TURKEY POINT NUCLEAR GENERATING UNIT NO. 3

Amendment No. 57
License No. DPR-31

Amendment No. 50
License No. DPR-41

SAFETY EVALUATION BY THE OFFICE OF NUCLEAR REACTOR REGULATION
RELATED TO AMENDMENT NO. 57 TO FACILITY OPERATING LICENSE NO. DPR-31
AND AMENDMENT NO. 50 TO FACILITY OPERATING LICENSE NO. DPR-41

Figure 3.2-3b

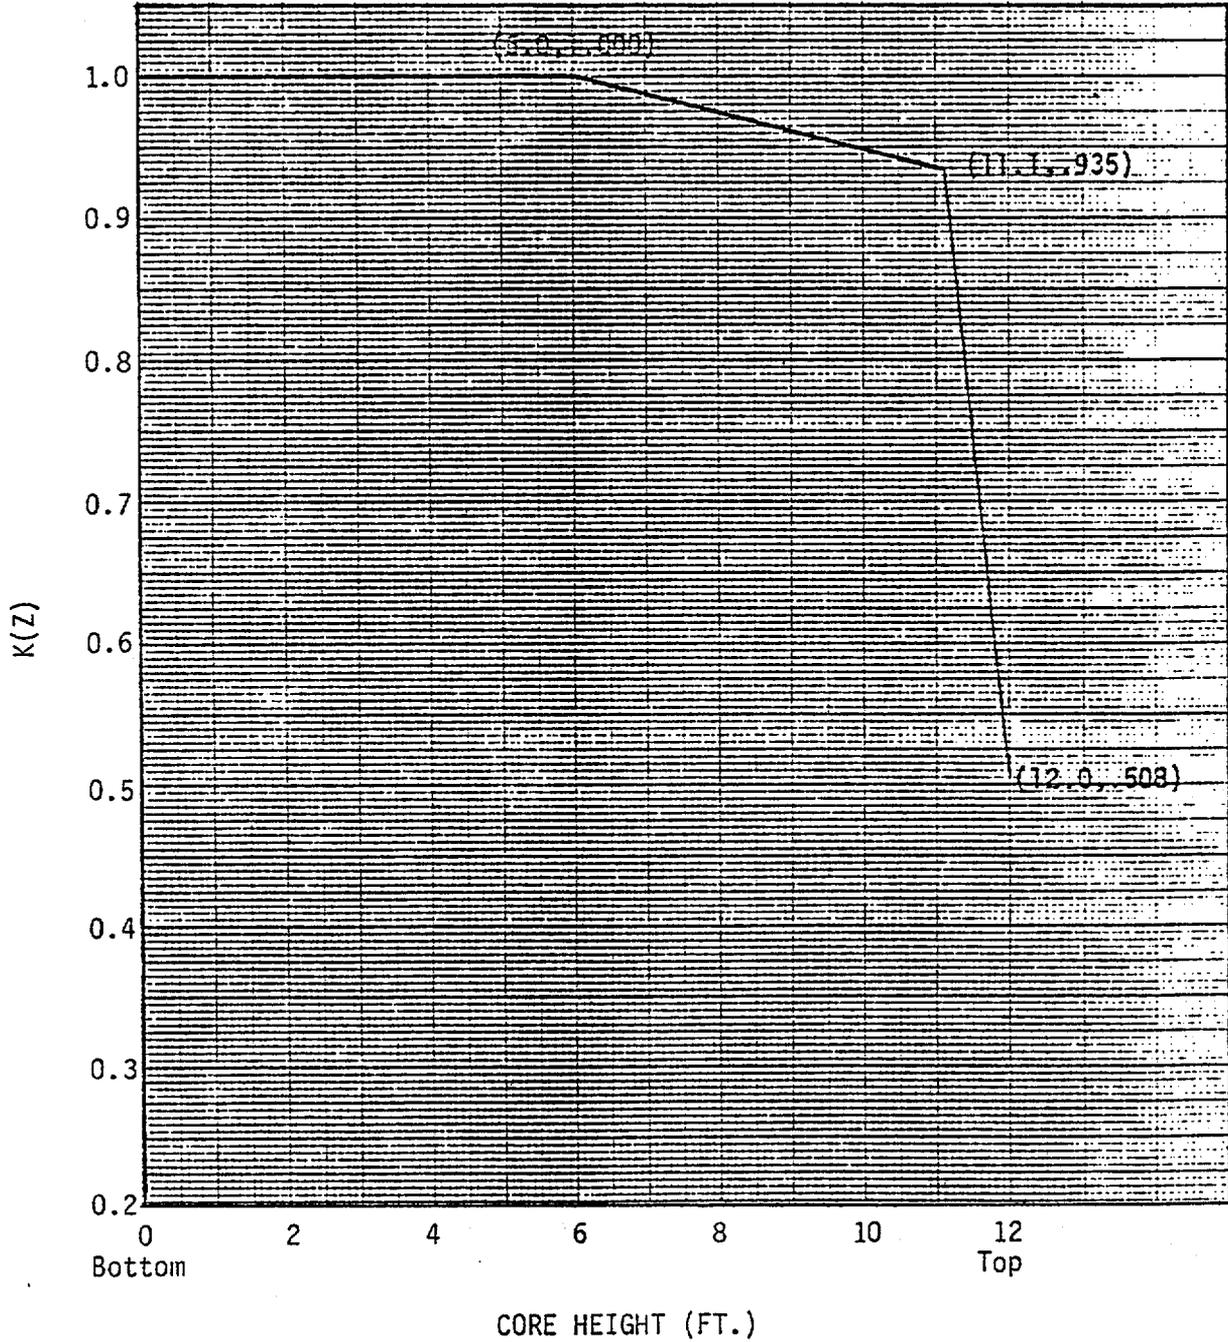
Where P is the fraction of rated power at which the core is operating; K(Z) is the function given in Figure 3.2-3b; Z is the core height location of F_q .

- (a) Specification of $F_0 = 1.97$ for plant operation with 25 percent of steam generator tubes plugged.
- (b) Change of the Hot Channel Factor Normalized Operating Envelope for a steam generator tube plugging level of 25 percent (Figure 3.2-3b)

- (1) With steam generator tube plugging >22% and ≤25%, the hot channel factors (defined in the basis) must meet the following limits at all times except during low power physics tests:

$$F_q(Z) \leq (1.97/P) \times K(Z), \text{ for } P > .5$$

$$F_q(Z) \leq (3.94) \times K(Z), \text{ for } P \leq .5$$

Based on the review of the submitted documents, we conclude that the results of the LOCA analysis performed with $F_Q = 1.97$ are conservative relative to the 10 CFR 50.46 criteria. We consider the resultant changes to the Technical Specifications acceptable for operating Units 3 and 4 with up to a maximum of 25 percent of steam generator tubes plugged.
